Re: Precision Eye Center 7521 Alameda Blvd. NE Traffic Circulation Layout Engineer's Stamp 04-20-23 (C19-D070)

### Re: C19-D070 Responses to TCL Comments received on 4/20/2023

**C102**

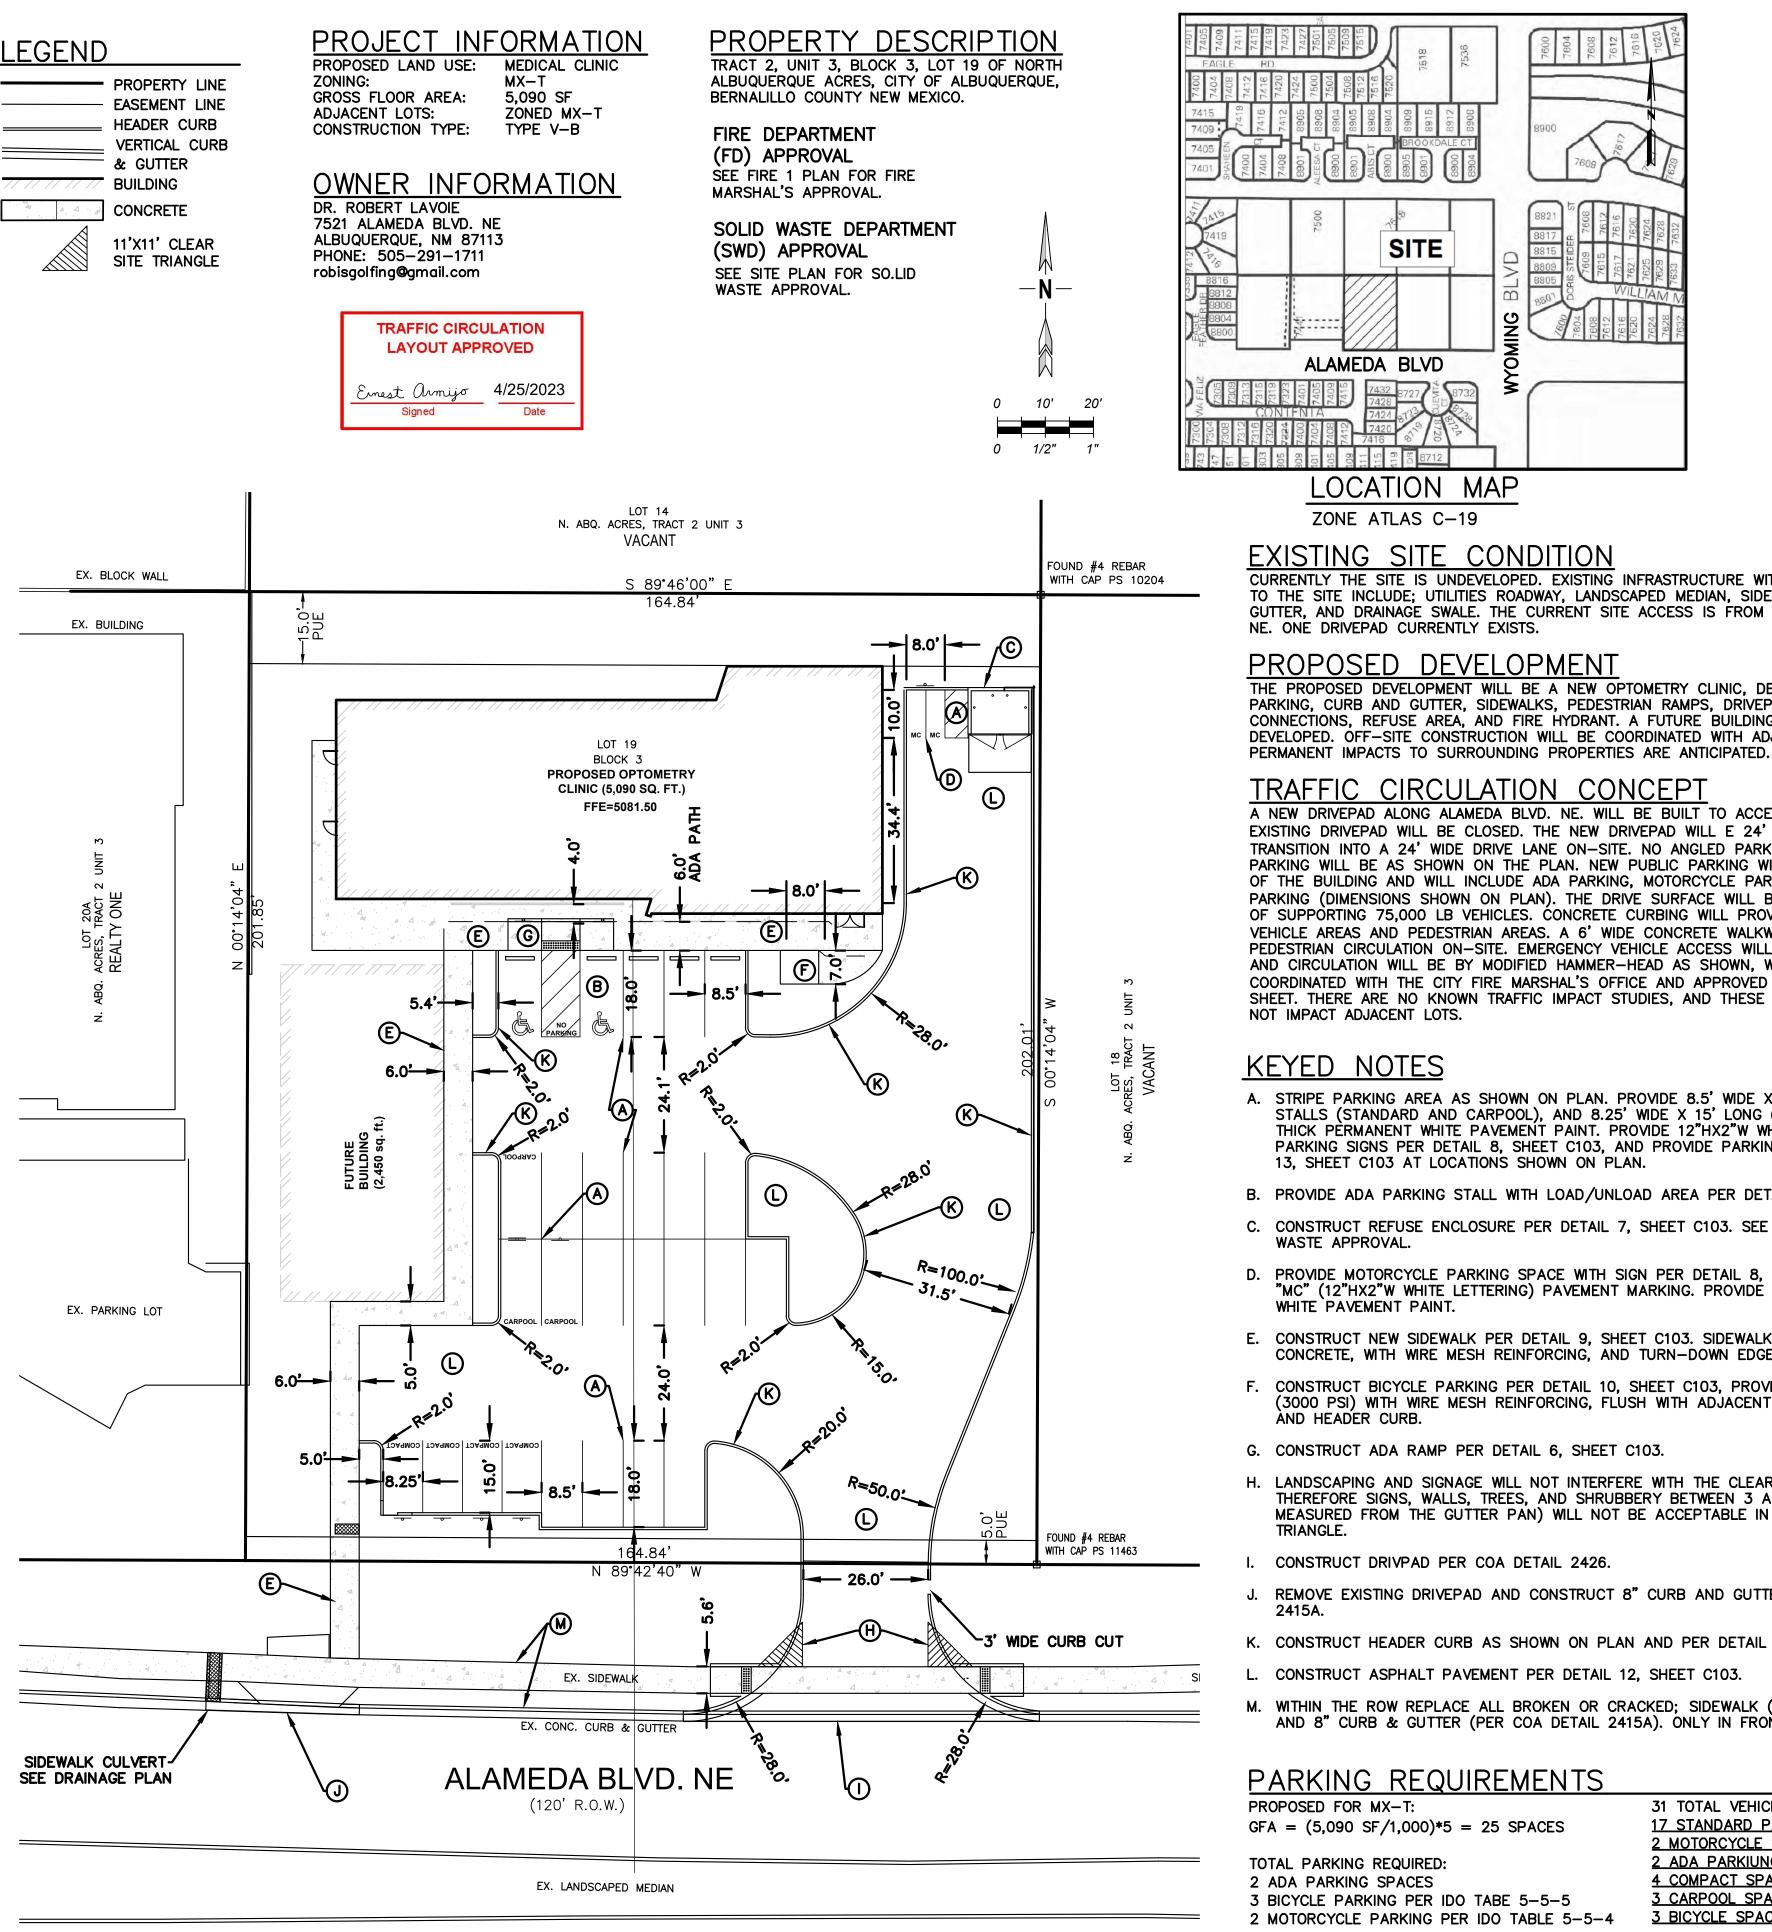
- Please show on the site plan the radius for the site access. Radius dimension line added
- Provide 6 ft. wide ADA pathway from the public sidewalk to the building entrance. 6ft wide path now shown

- Please show on the site plan the 6 ft. wide ADA pathway from the ADA parking aisle to building entrance. Provide the width for the highlighted way (key note E).
  6ft wide path now shown

- Add a note stating "All broken or cracked sidewalk must be replaced with sidewalk and curb & gutter." A build note must be provided referring to the appropriate City Standard drawing.
  See keyed note "M"

Number: C103

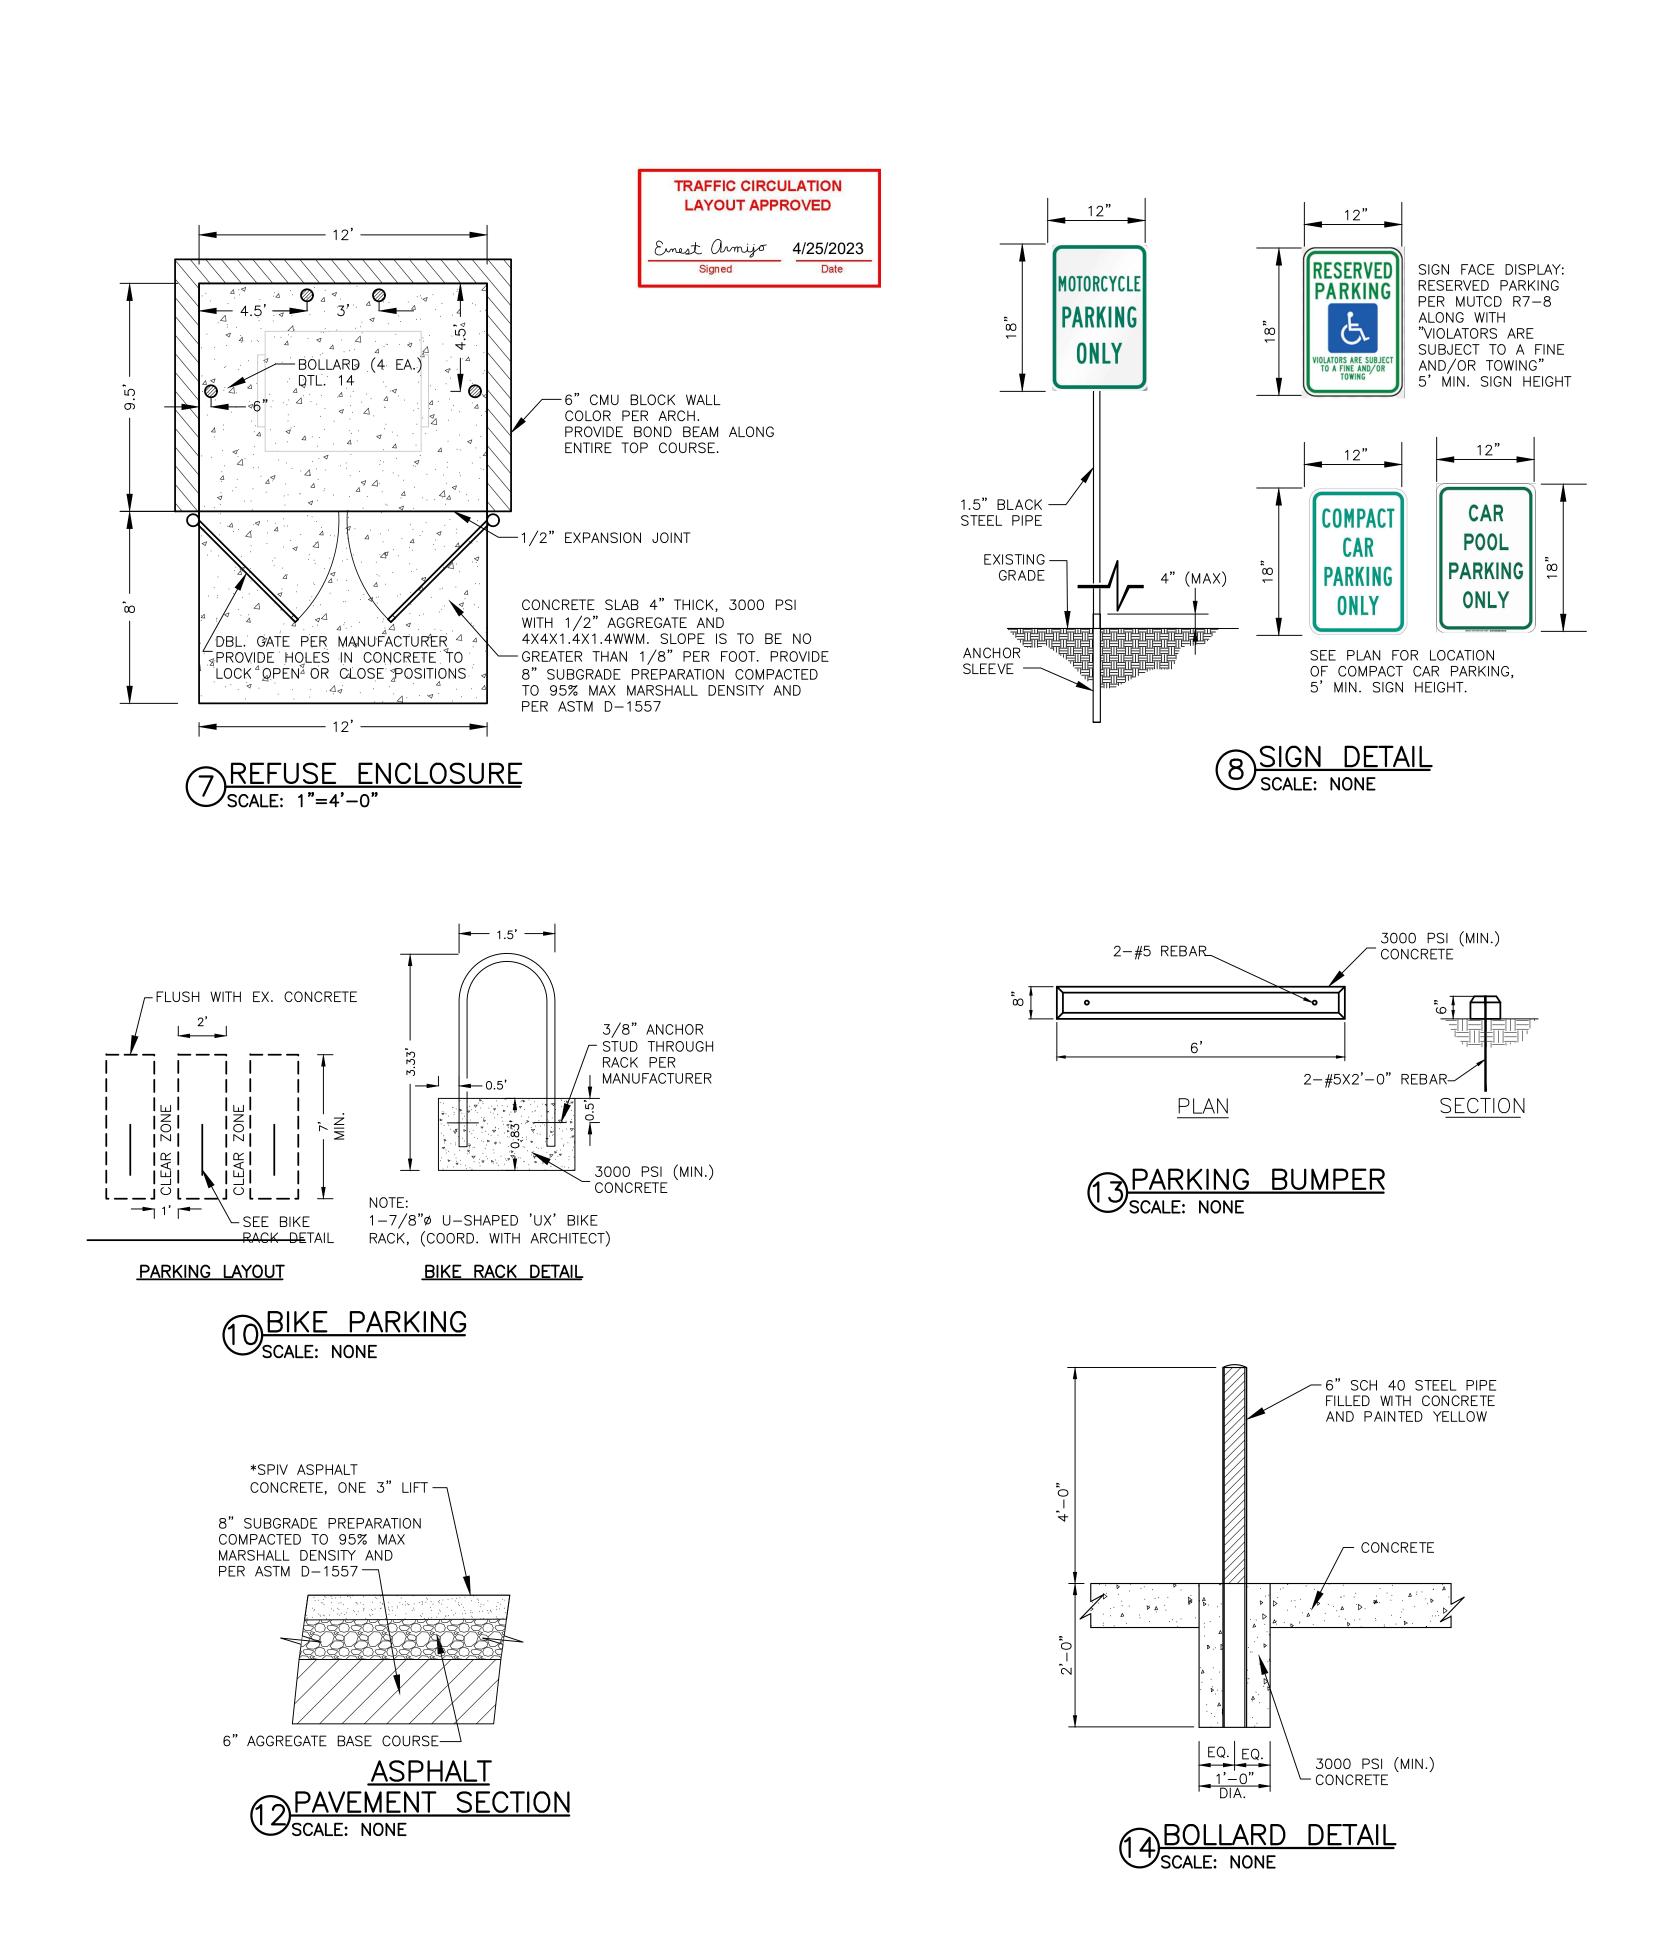
- Details sheet is missing. Detail sheet added
- Please provide details for all the proposed signs and pavement marking. Shown on detail sheet
- Provide Bike Rack details. Shown on detail sheet
